Access Compliance Report

Public Rights-of-Way

(Curb Ramps)

Intersection ID: N/A	Main Street: REA_RD	Cross Street: CEDAR_CROFT_DR	Location: N
ADA ID: B4179D2F5842	Ramp Type: Perp	Initial Pass/Fail: Fail	Overall Compliance: No
Severity Score: 13.75			
Codes/Mitigation Info/Possible Solution		Field Measurements/Component Compliance

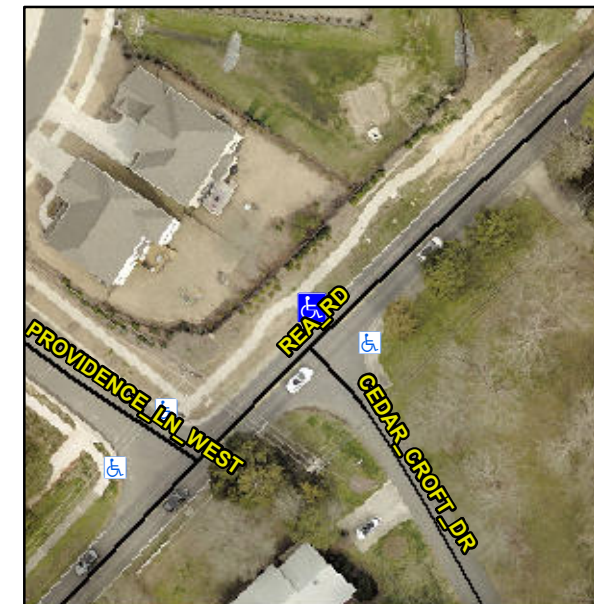
Not Found, R304.2.2, R304.5.3

Compliance	Description	Data	Compliance	Description	Data
N/A	Ramp Length (in)	103.0	No	Ramp Slope (%)	11.7
Yes	Ramp Width (in)	48.0	No	Ramp XSlope (%)	3.1
N/A	Flare Type LT	N/A	N/A	Flare Type RT	N/A
N/A	Flare Slope LT (%)	N/A	N/A	Flare Slope RT (%)	N/A
N/A	Flare Traversable LT?	N/A	N/A	Flare Traversable RT?	N/A
N/A	Landing Length (in)	N/A	N/A	DWS Provided?	N/A
N/A	Landing Width (in)	N/A	N/A	DWS Contrast?	N/A
N/A	Landing Slope (%)	N/A	N/A	DWS Length (in)	N/A
N/A	Landing X Slope (%)	N/A	N/A	DWS Full Width?	N/A
N/A	Landing Curb? (Y/N)	N/A	N/A	DWS Offset (in)	N/A
N/A	Shared Landing?	N/A			
N/A	Gutter Ponding?	N/A	N/A	Gutter Slope (%)	N/A
N/A	Gutter Lip Ht (in)	N/A	N/A	Gutter X Slope (%)	N/A
N/A	Painted X Walk1?	No	N/A	Painted X Walk2?	N/A
	X Walk 1 Direction	To SE		X Walk 2 Direction	N/A
N/A	X Walk 1 Width (in)	N/A	N/A	X Walk 2 Width (in)	N/A
	X Walk 1 Slope (%)	0.9		X Walk 2 Slope (%)	N/A
	X Walk 1 X Slope (%)	1.7		X Walk 2 X Slope (%)	N/A

Remove & Replace Entire Ramp.
